**Name & Number of Project:** Hart Residence  
SP-2011-0037D(R1)

**Request:** 1) A variance to 25-8-261 to allow the construction of third access to an existing boat dock, which is not allowed in a CWQZ.

## MEMORANDUM

**SUBJECT:** Hart Residence – SP-2011-0037D(R1)

Title: **DIMENSIONAL SITE PLAN**

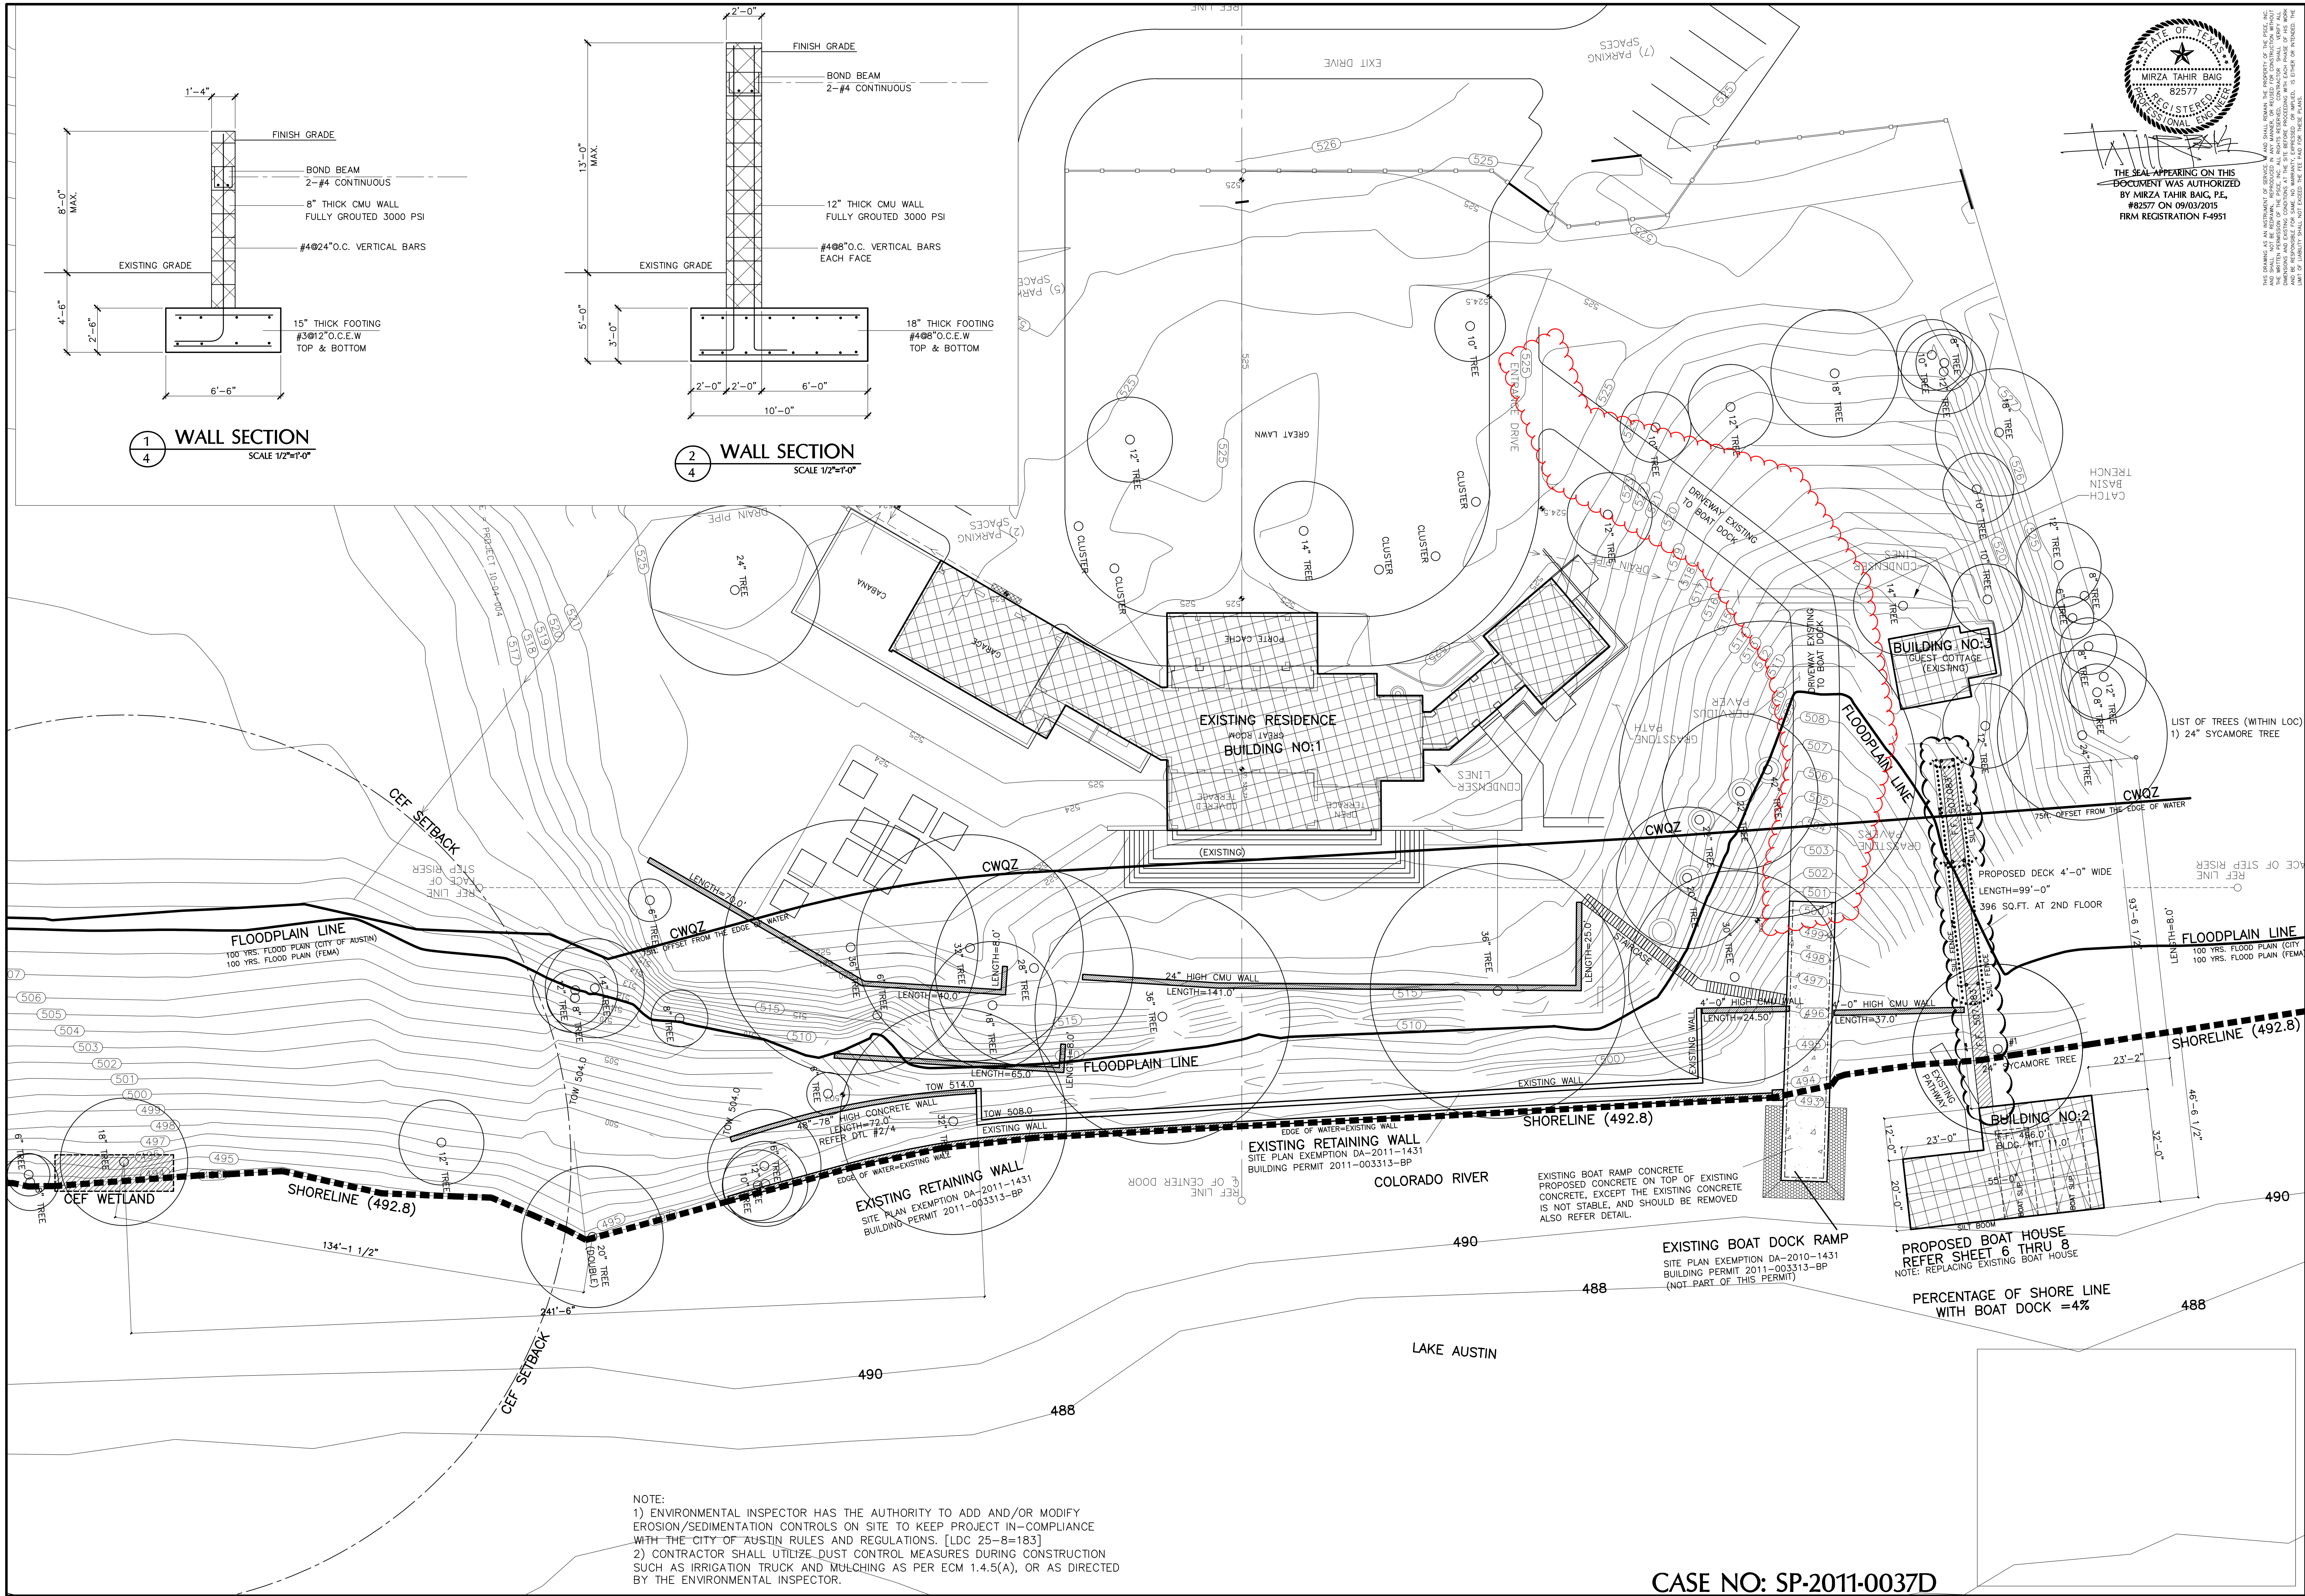
A variance is requested for construction not allowed in a Critical Water Quality Zone (CWQZ). Per 25-8-261(C), boat docks and necessary access and appurtenances are allowed in a CWQZ along Lake Austin. Since this property already contains two shoreline access points, the applicant does not wish to remove, staff does not find the addition of a third access meets the intent of “necessary shoreline access”.

**No, the variance is specifically triggered by how the applicant has chosen to develop the property. There are currently two points of existing shoreline access to the boat dock, the applicant could choose to remove the existing boat ramp and stone steps used for access and restore and revegetate the disturbed area within the Critical Water Quality Zone. This restoration would eliminate the need for a CWQZ variance entirely.**

**No, the variance is not the minimum change necessary to allow reasonable use of the property. Minimum change could be to retrofit an existing access and maintain the existing two points of access; instead the applicant is proposing a new shoreline access, which would be a third point of access.**

**No, disturbance within the Critical Water Quality Zone is limited in order to preserve the integrity of the riparian corridor. While construction of a single access may have a minimal footprint, allowing a third access could lead to continued degradation of the Lake Austin riparian corridor at this site and set precedent for future, similar requests.**

**No. Though structural water quality controls are not required for boat dock or shoreline access, the proposed development creates additional disturbance in the Critical Water Quality Zone, including additional impervious cover.**

**No, reasonable economic use of the property is a single family residence and a boat dock with necessary shoreline access which already exists. The proposed construction of an aerial boardwalk in addition to the existing shoreline access is not considered to be "necessary" access.**

**No, the minimum change necessary would include removing the existing shoreline access or possibly retrofitting the existing access.**
